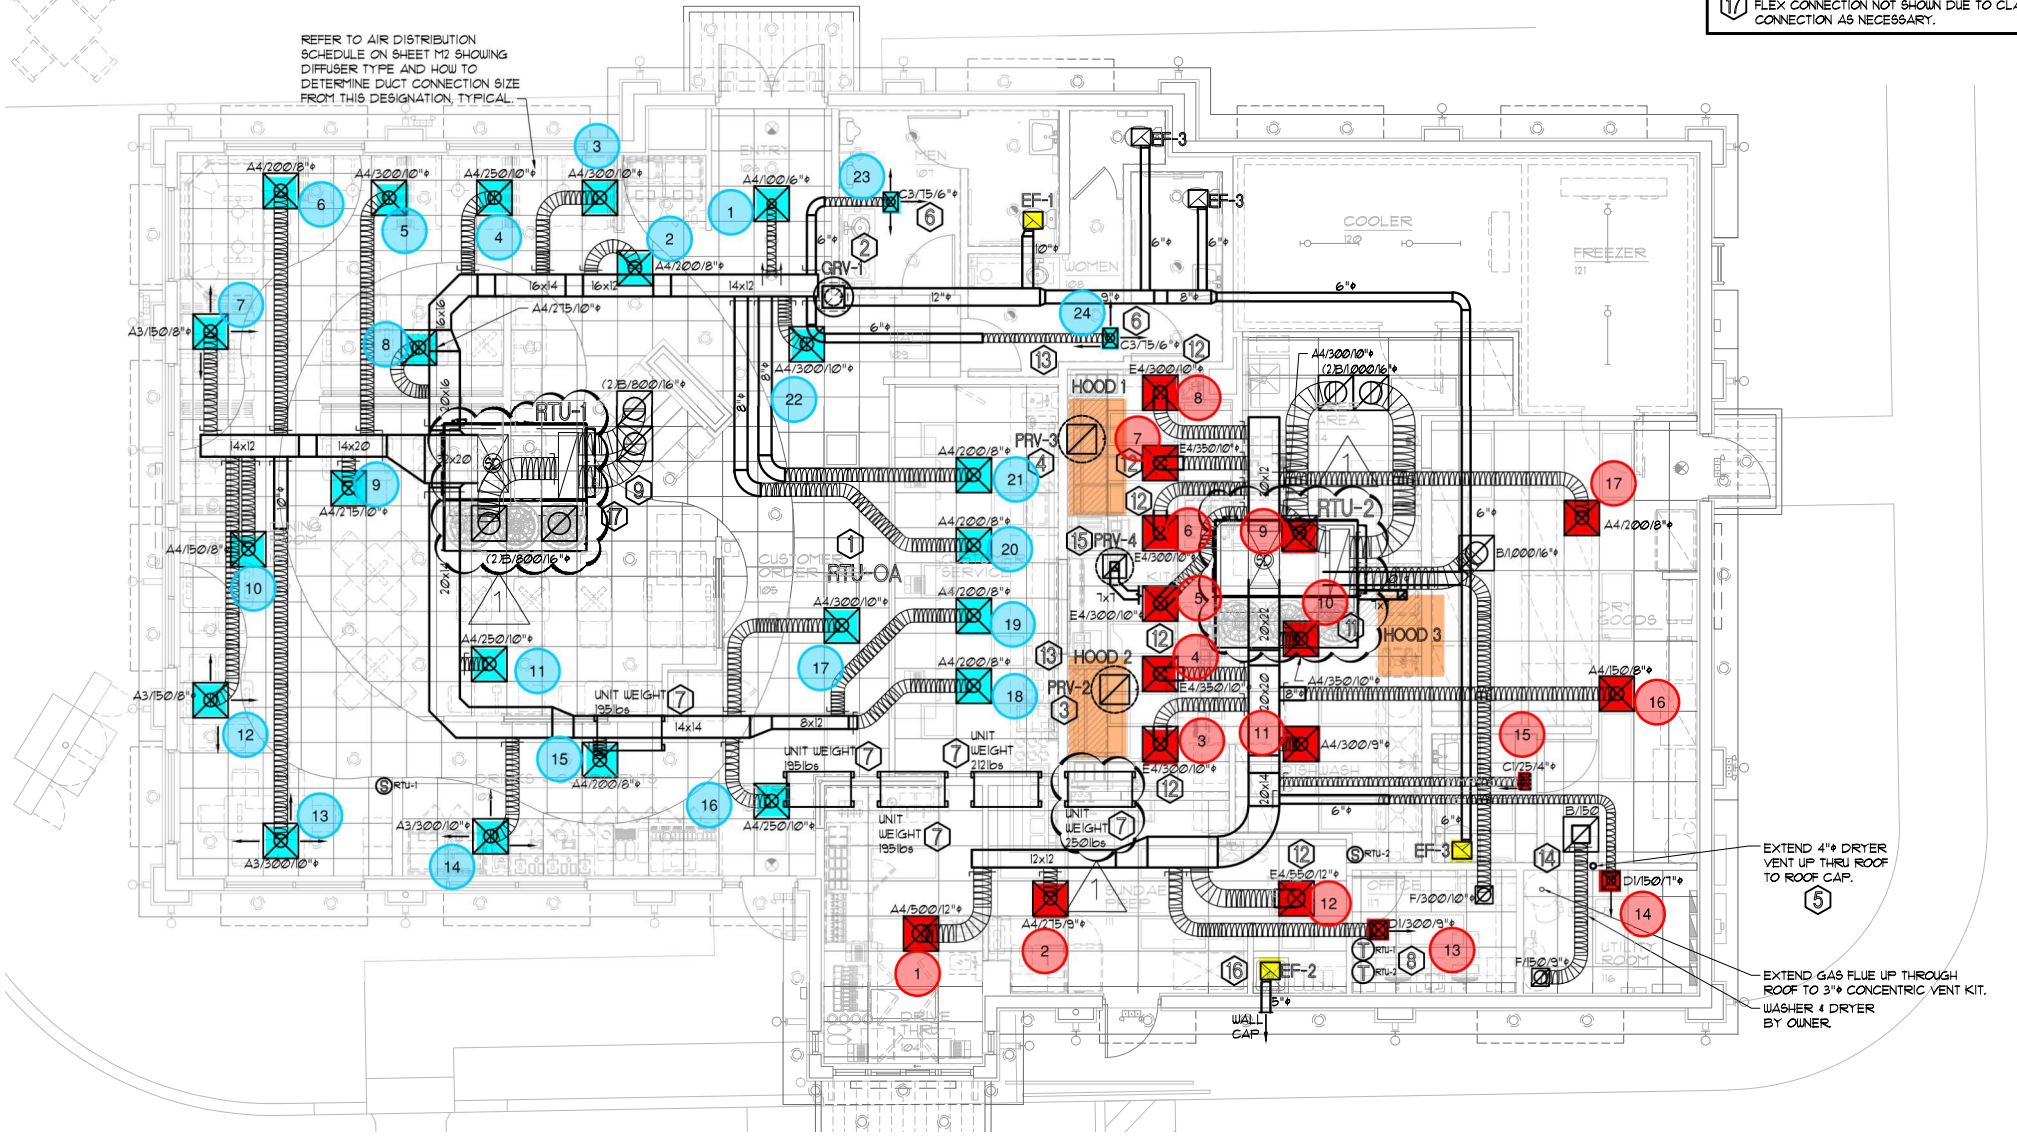
MORE THAN REQUIRED. TOTAL OUTSIDE AIR FOR BOTH ZONES IS EXCEEDED.

(16) PROVIDE INDEPENDENT ON/OFF SWITCH FO
BASIN.

(17) FLEX CONNECTION NOT SHOWN DUE TO CLA
CONNECTION AS NECESSARY.
